**CITY OF BOULDER**  
**LAND USE REVIEW RESULTS AND COMMENTS**

DATE OF COMMENTS: **May 7, 2010**  
CASE MANAGER: **Elaine McLaughlin**  
PROJECT NAME: **HIGH MAR**  
LOCATION: **4990 MOORHEAD AV**  
COORDINATES: **S02W02**  
REVIEW TYPE: **Concept Plan Review & Comment**  
REVIEW NUMBER: **LUR2010-00020**  
APPLICANT: **JEFF DAWSON**  
DESCRIPTION: **CONCEPT REVIEW - For a 59-unit affordable housing project with six residential buildings and one community center.**

**Figure 1:  
Comparison of Three Site Design Approaches**

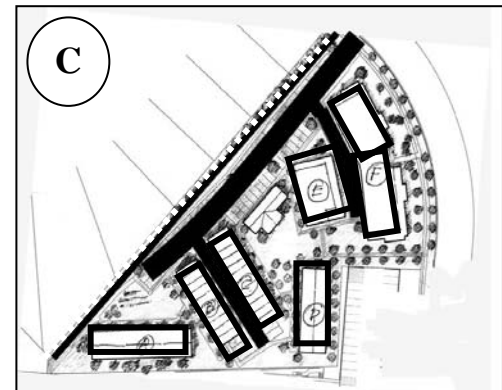
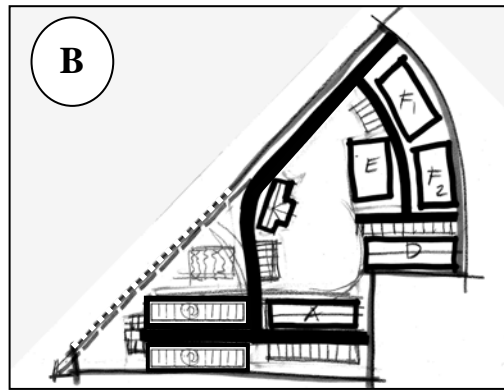
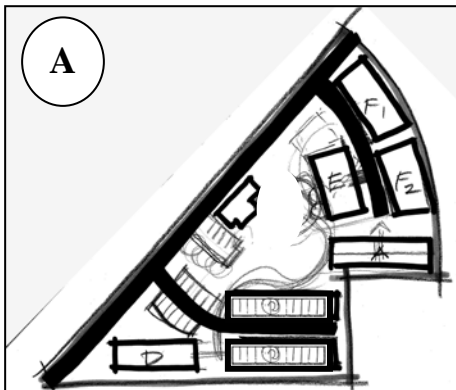
3. The thumbnail graphics below illustrate two options, (A) and (B), as a comparison to the concept plan (C). The two alternatives provide approaches with the following objectives:

(A) This option illustrates:

- A shared access drive/bike route option with a separate 8-foot wide multi-use path.
- No parking would align the drive, so less interference between vehicles and bikes would occur.
- A central open space is provided, and an option to shift building E toward the west would provide a larger area of internal open space.
- Buildings b, c, and d are all clustered on the south end, buildings a, e, and f (as two buildings) are clustered on the north end.
- Approximately 30 surface parking spaces scattered across the site.

(B) This option illustrates:

- A shared access drive/bike route option with a separate 8-foot wide multi-use path for the north portion of the access drive. The multi-use path then comes back together as a joint 12-foot wide facility.
- No parking would align the drive, so less interference between vehicles and bikes would occur.
- A central open space is provided, and an option to shift building E toward the west would provide a larger area of internal open space.
- Approximately 30 surface parking spaces scattered across the site.

(C) The submitted Concept Review plan as illustrated has several potential areas of improvement:

- The shared access drive with the bike route would be impacted by backing vehicles.
- The parallel parking along the west side of the drive has no means for vehicles to turn around.
- The cross-section becomes a very wide pavement section.
- Building “a” is isolated away from the rest of the development and doesn’t appear to have close-in parking to serve the building.
- Building “d” does not appear to have parking nearby to serve the units.
